Well Name: POKER LAKE UNIT 22 DTD	Well Location: T24S / R30E / SEC 22 / NENE /	County or Parish/State:
Well Number: 128H	Type of Well: CONVENTIONAL GAS WELL	Allottee or Tribe Name:
Lease Number: NMNM068905	Unit or CA Name:	Unit or CA Number:
US Well Number: 3001549867	Well Status: Approved Application for Permit to Drill	Operator: XTO PERMIAN OPERATING LLC

Sundry ID: 2762134

Type of Submission: Notice of Intent **Type of Action:** APD Change

Procedure Description: XTO Permian Operating LLC. respectfully requests approval to make changes to the Approved APD as follows: SHL, BHL, FTP, LTP, Directional Drilling Plan, Casing and cement change SHL: FROM: 423' FNL & 1295' FWL TO: 328' FNL & 806' FEL of Section 22-T24S-R30E BHL: FROM: 201' FNL & 197' FEL TO: 230' FNL & 400' FEL of Section 3-T24S-R30E FTP: FROM: 100' FNL & 256' FEL TO: 328' FNL & 806' FEL of Section 22-T24S-R30E LTP: FROM: 330' FNL & 198' FEL TO: 330' FNL & 400' FEL of Section 3-T24S-R30E DRILLING AND CASING PLAN: 6" P-110 26# production casing will be run instead of 5-1/2" P-110 23# production casing. ATTACHMENTS: New C-102, Drilling and Casing Plan, Directional Plan, Wellhead Design, Casing Spec Sheet, BOP Variance Re

WELL LOCATION AND ACREAGE DEDICATION PLAT

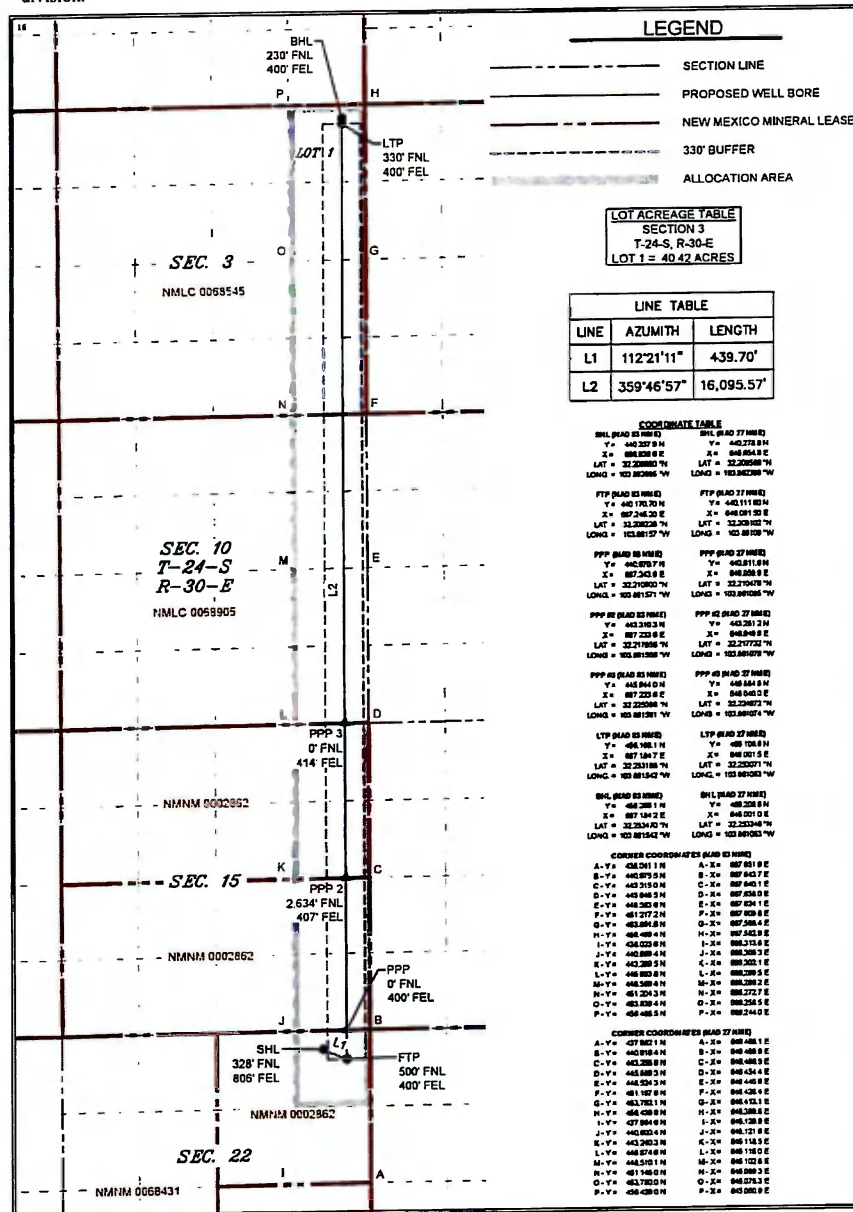
UL or lot no.	Section	Township	Range	Lot Idn	Feet from the	North/South line	Feet from the	East/West line	County
A	22	24S	30E		328	NORTH	806	EAST	EDDY

UL or lot no.	Section	Township	Range	Lot Idn	Feet from the	North/South line	Feet from the	East/West line	County
1	3	24S	30E		230	NORTH	400	EAST	EDDY
